January 15, 2014

## **MEMORANDUM**

SUBJECT: Staff Analysis for Draft Reuse Permit M-080-04 (formerly LA-000080-03)  
Bogus Basin Recreation Association, Inc.

Figure 1: Total Kjeldhal Nitrogen (TKN) concentration in Bogus Creek upstream and downstream of the site.

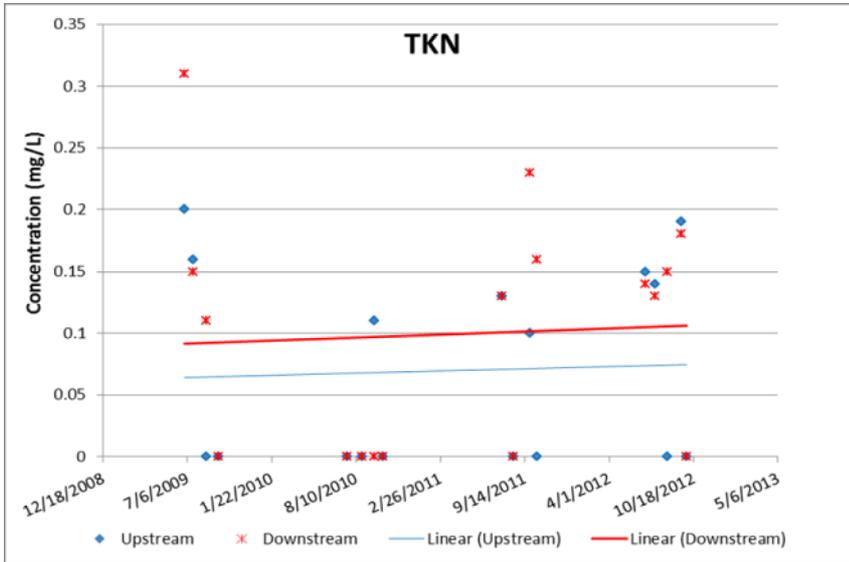
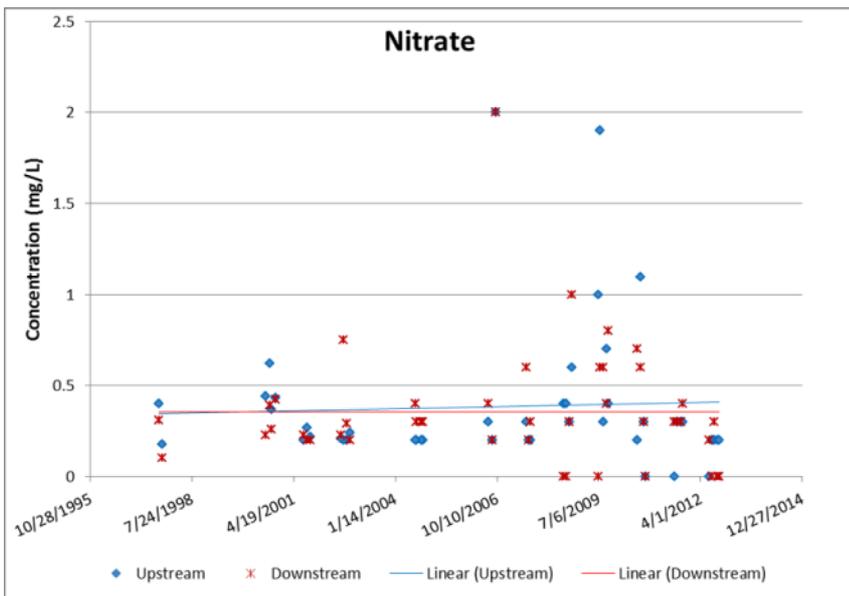
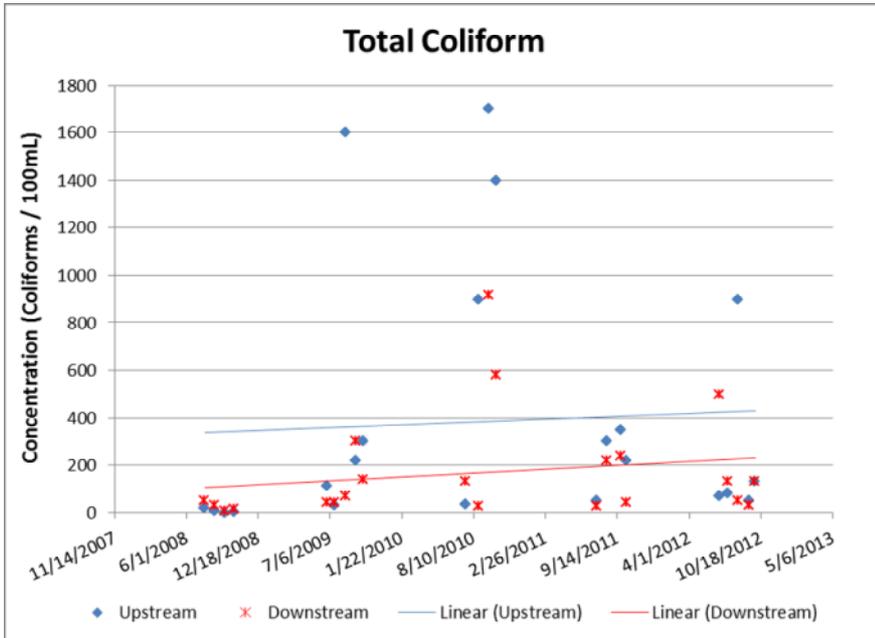
The concentrations in the creek are not at a level of concern, and there does not appear to be any trending that does not appear both upstream and downstream of the site. It is recommended that the facility continue to monitor the stream, but that monitoring be conducted for constituents of concern in surface water. Therefore, instead of TKN and total coliform, the facility would monitor ammonia and *E.coli*, as well as pH and temperature which are needed to assess the impact of ammonia on the water body. Nitrate and total phosphorus would continue to be monitored.

The draft permit includes a requirement to conduct soil monitoring twice during this permit term at four year intervals; the constituents required were not changed. Bogus Creek is sampled every month that water is applied to the site. The constituents were upgraded to those required by surface water programs: *E.coli* is required instead of total coliform; ammonia is required instead of TKN; pH and temperature were added; and nitrate and total phosphorus were carried over from the current permit.
